**Re: Natural Gas Combined Cycle Minor Modification
Electric Transmission Line and Storm Outfalls Rehabilitation
NPDES Permit #: PAC060046
BCCD Project ID #: ESP-00731
Dawood Project No. 216040.01**

Enclosed, please find revised documents for the above-referenced project updated to accommodate the installation of poles required to connect the substation to the existing overhead line north of the substation site off Boonetown Road. These documents have been revised to adjust the limit of disturbance, show E&S control for the additional area, and demonstrate that the 2-year volume increase associated with the two pole foundations does not exceed the predevelopment volume for the site.

B106

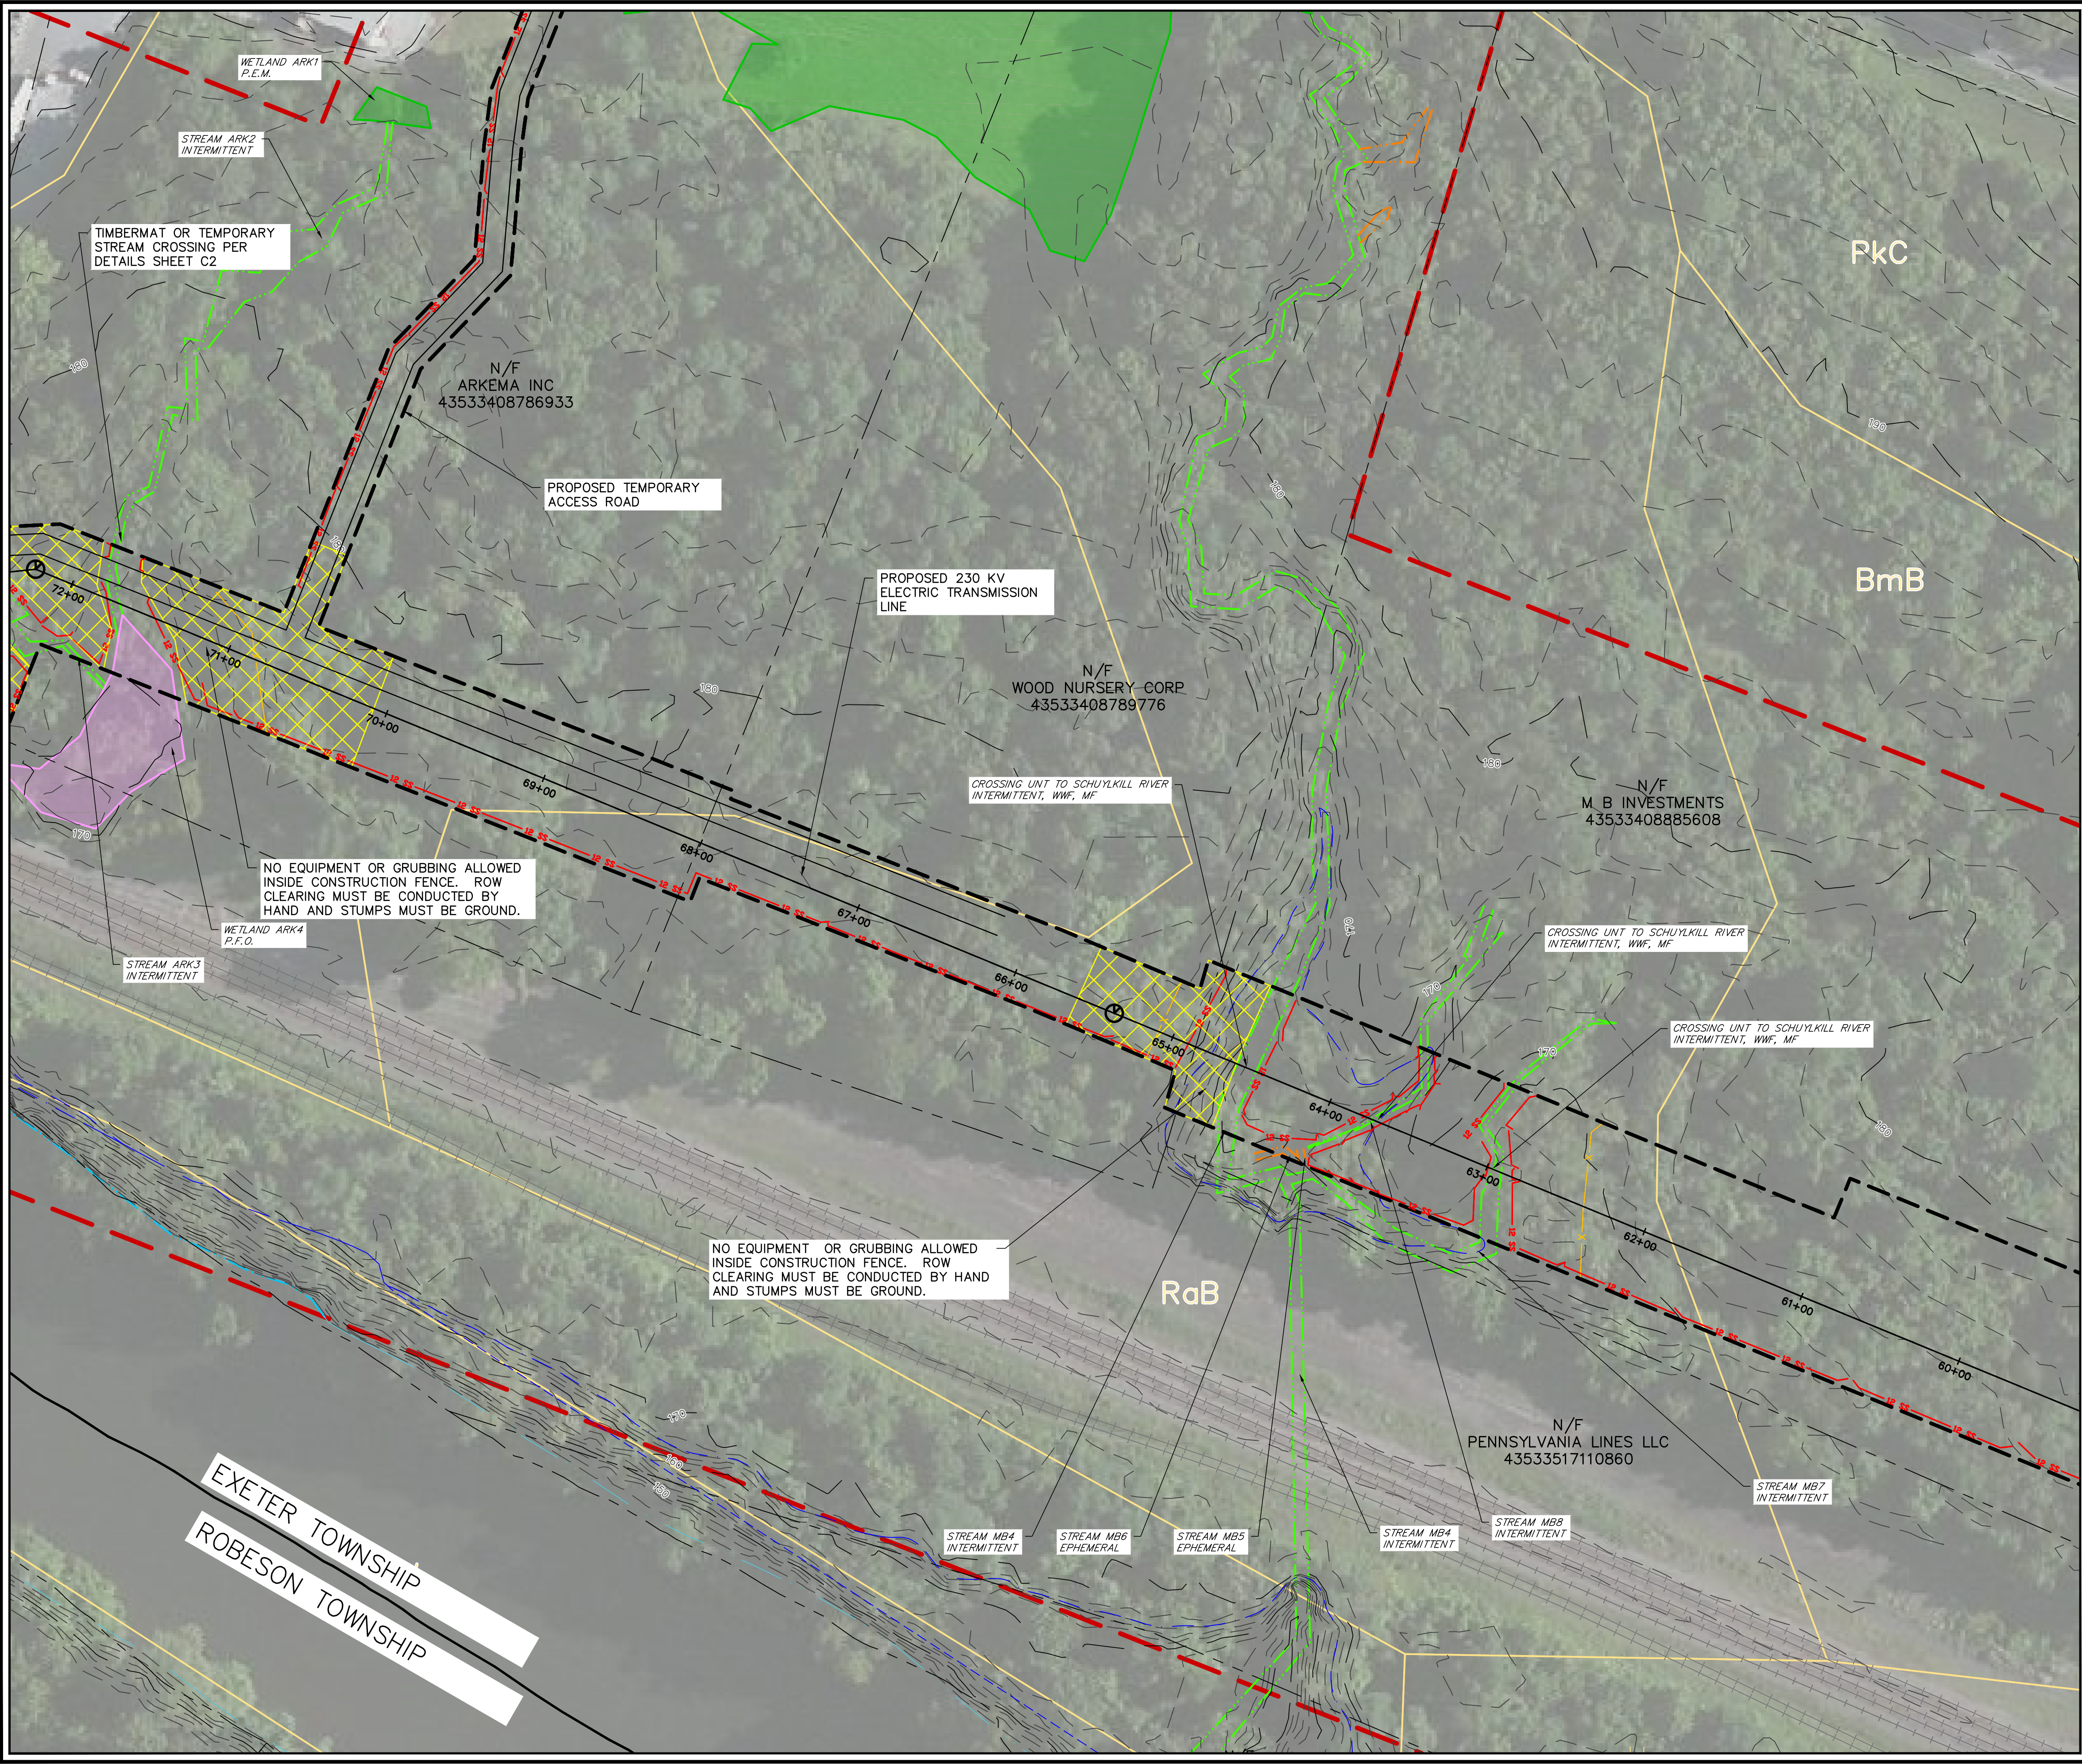
7. ESCP B103 (Page 402)– Total Disturbed area has been decreased to from a 150' wide maximum limit of disturbance to a 100' wide maximum limit of disturbance from station 23+00 to 24+50 based on comments received from Chapter 105 review.
8. ESCP B106 (Page 405)– Total Disturbed area has been decreased to from a 115' wide limit of disturbance to a 90' wide limit of disturbance from station 61+00 to 65+00 based on comments received from Chapter 105 review.

B116

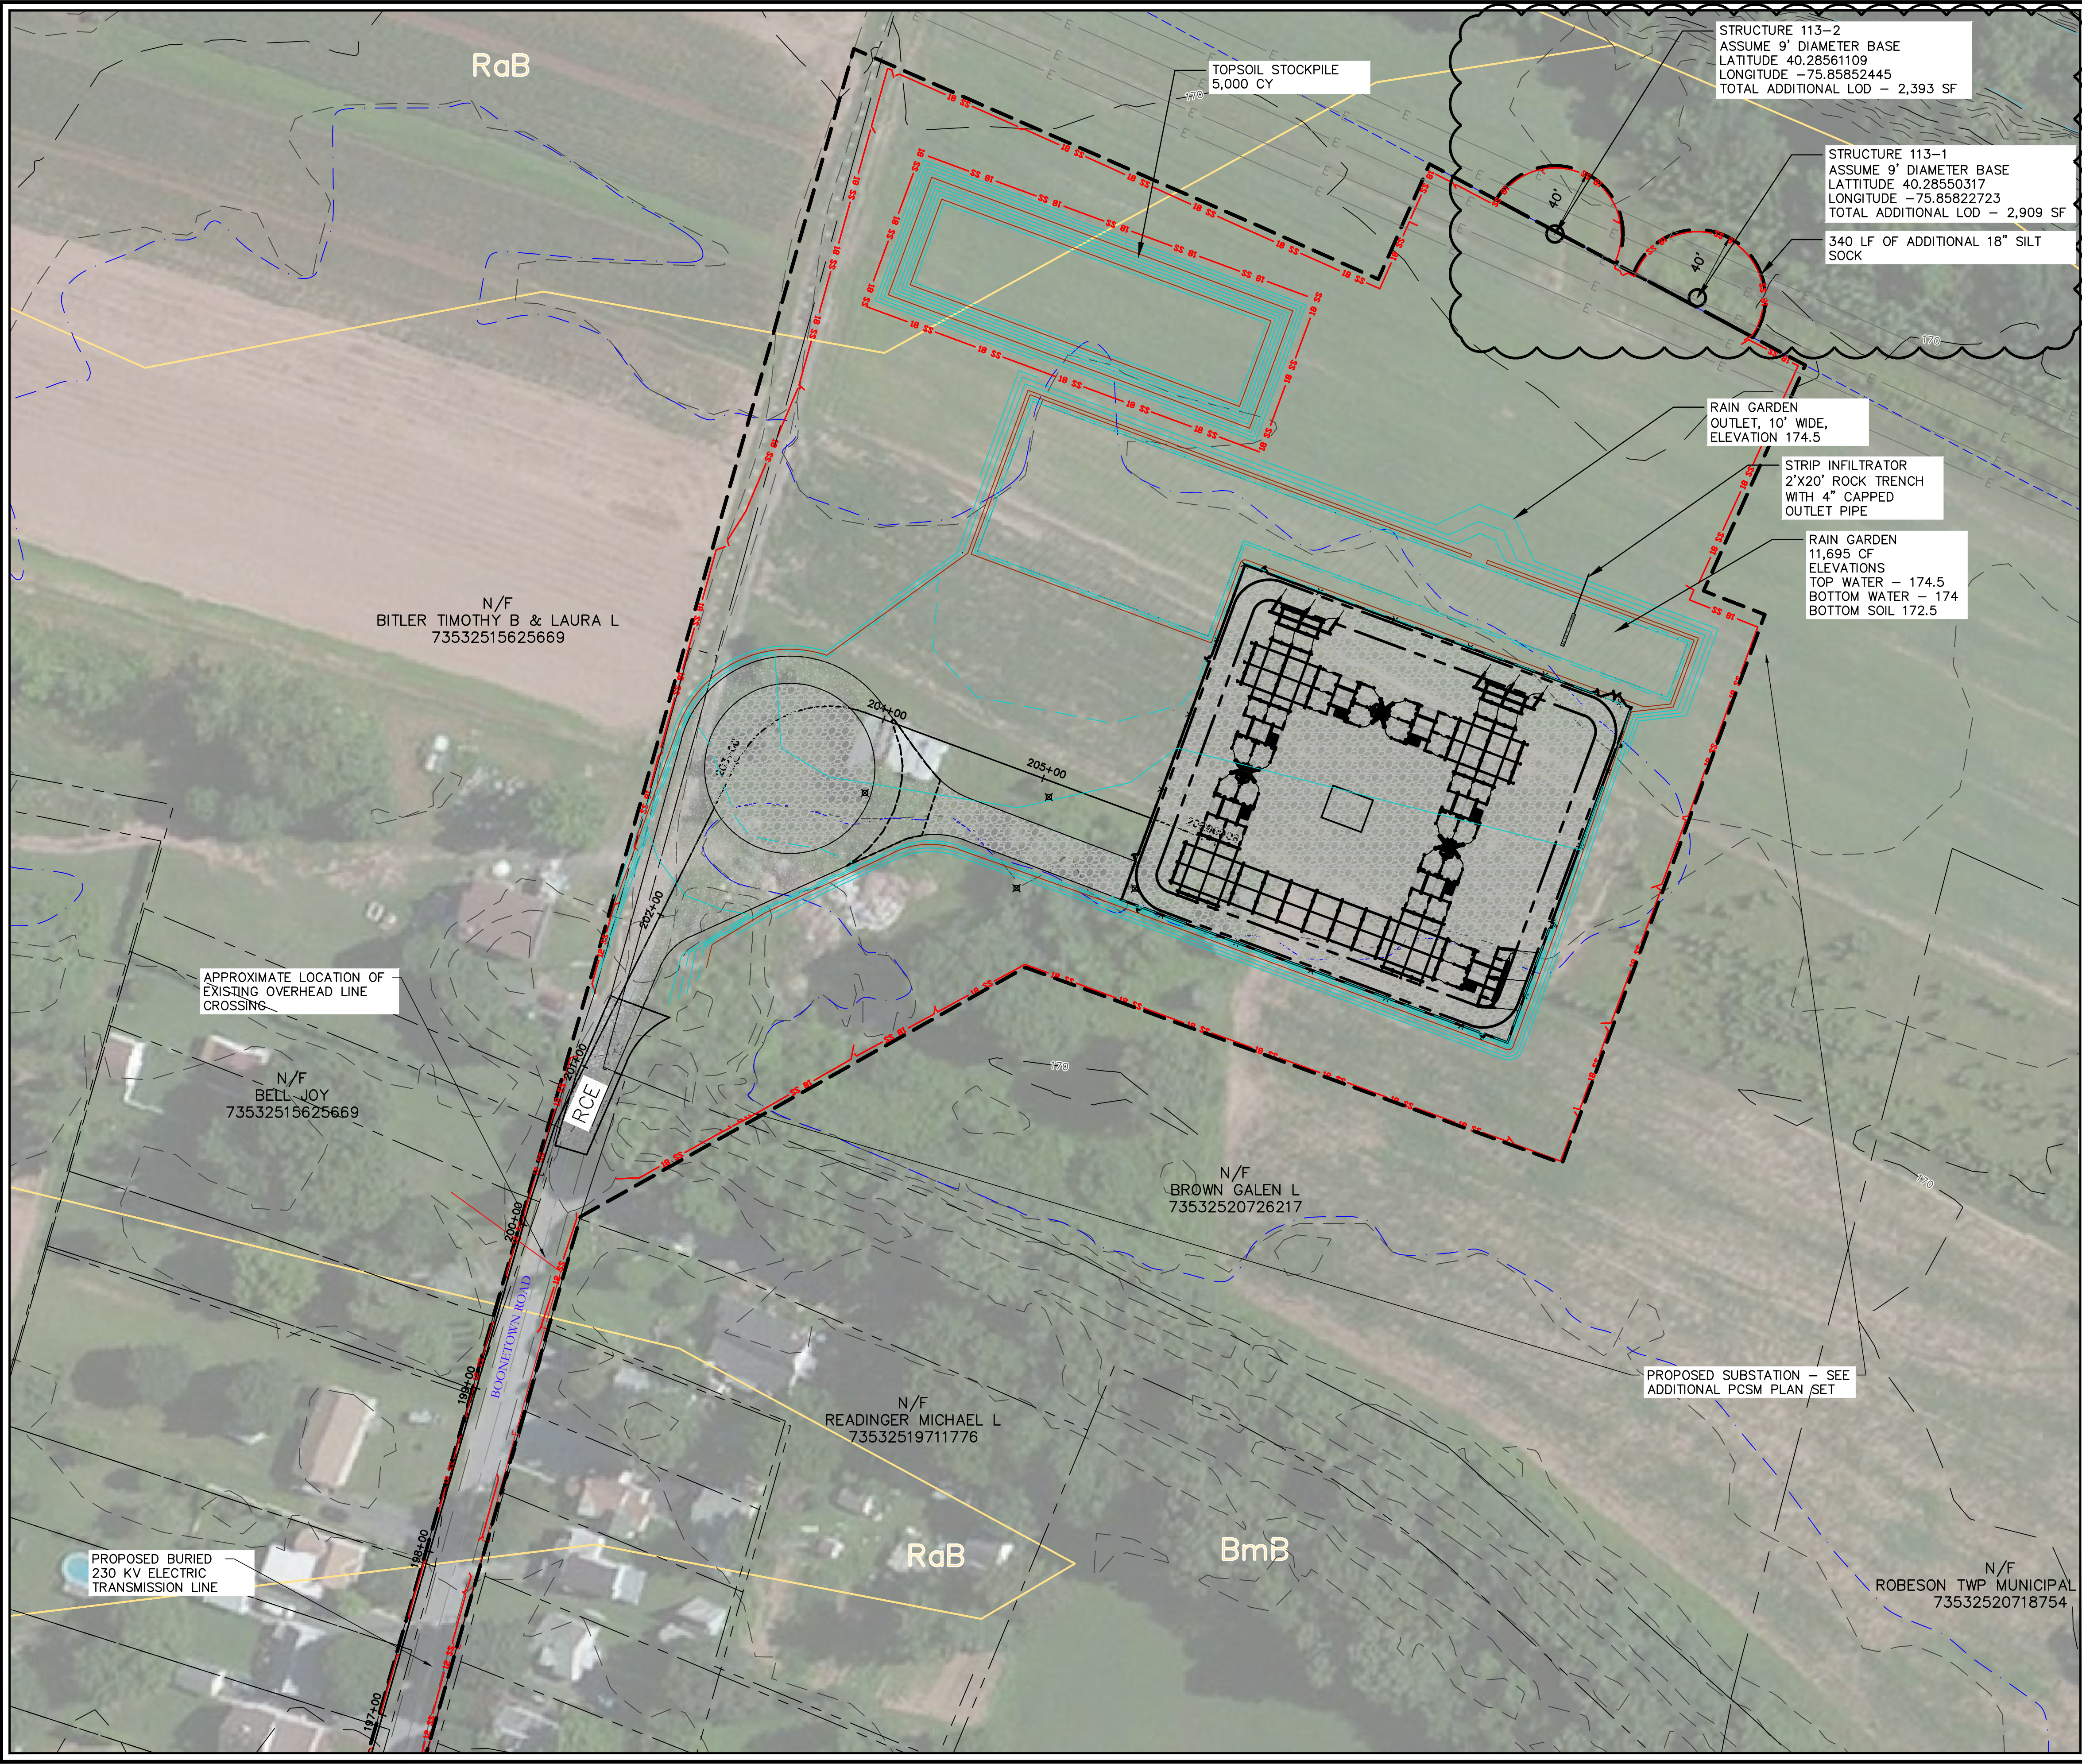
1. ESCP B116 (Page 416)– Total Disturbed area has been increased by 5,302 SF to allow installation of connection poles. Additional 18" silt sock is included for the disturbed area.
